Materials Reliability Program: Pressurized Water Reactor Internals Inspection and Evaluation Guidelines (MRP-227, Revision 1-A)

Final Report, June 2020

NRC Safety Evaluation

December 2019 Note: The changes proposed by the NRC in the Safety Evaluation as well those proposed by the EPRI Materials Reliability Program in response to NRC Requests for Additional Information (RAIs) have been incorporated into the current version of the report (MRP-227 Revision 1-A).

*Figure 4-37
Typical CE-Design Core Shroud Assembly (Welded Full-Height) Core Shroud
Assembly*

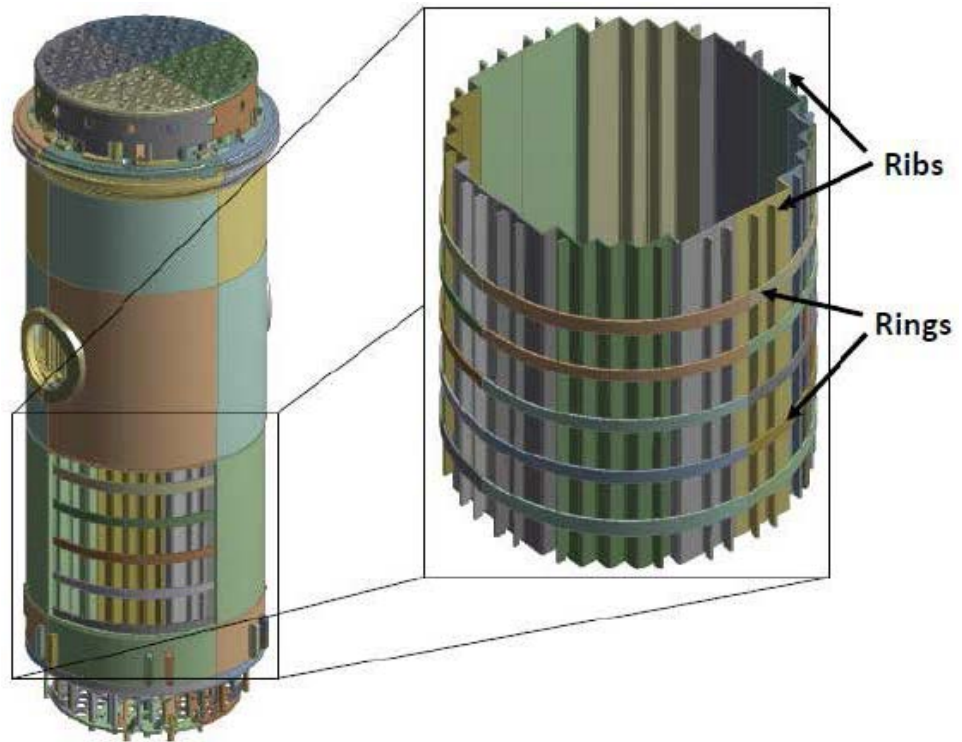
Also, in Figure 4-37, it is not clear if the core shroud assembly can be removed from the core support barrel assembly to allow examination of the ribs and rings. Therefore, in RAI 12, the NRC staff requested the following:

- a) For Item C2.1 and 3.1, does 75 percent of the remaining axial weld length for the remaining axial welds mean a minimum of 75 percent of the total accessible plus inaccessible length of these welds must be examined to claim examination credit?
- b) Justify the 25 percent sample size for the ribs and rings (Item C3.2).
- c) Clarify whether the ribs and rings are accessible for visual examination.

Figure 1: Approximate schematic sketch of the deep beam structure (figure from MRP-227-A)

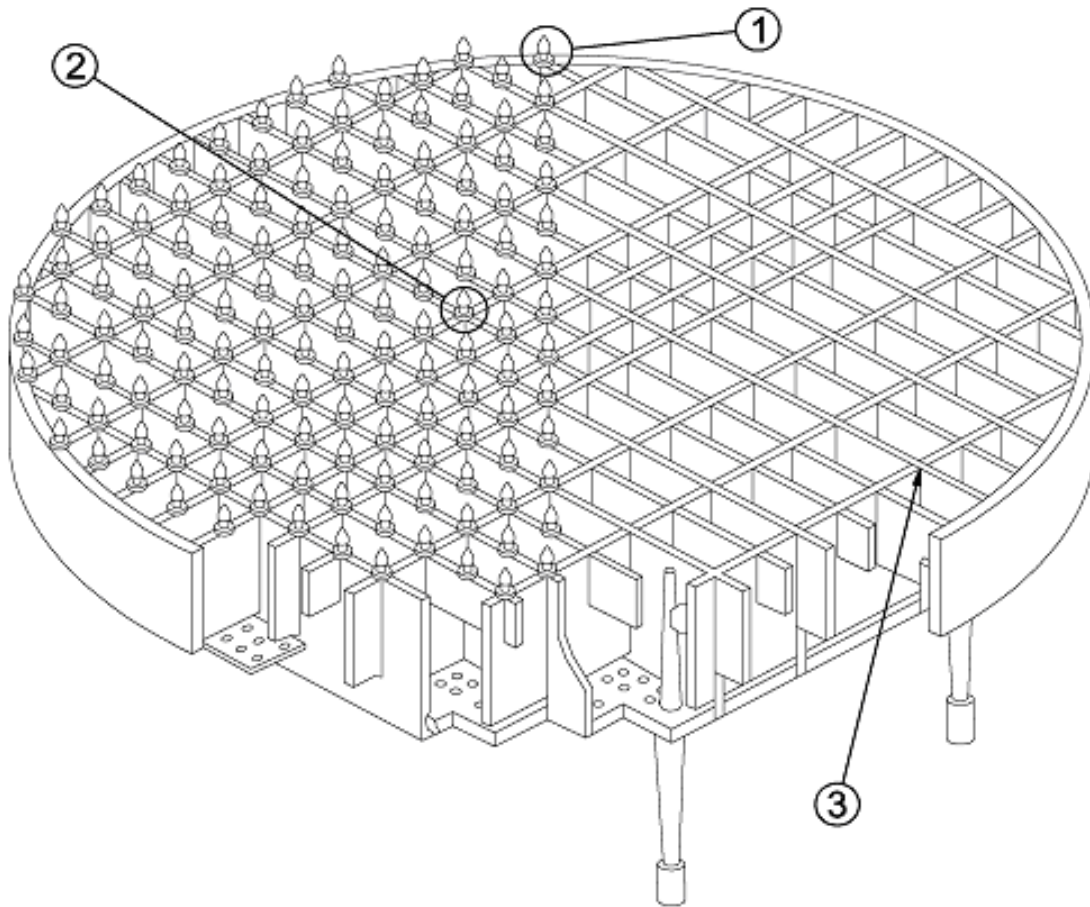
- a. Justify the required coverage of 25 percent as visible from above the core plate for Item C8 and W4.4 is sufficient to provide reasonable assurance of functionality.

- b. If degradation is found in the initial 25 percent inspection population, the examination would be expanded to include the remaining beam-to-beam welds. The deep beam line item in Table 4-2 of MRP-227, Revision 1 will be updated to include the reference to the existing Note 6 in the table, which specifies that the stated coverage requirement is the minimum if no significant indications are found.
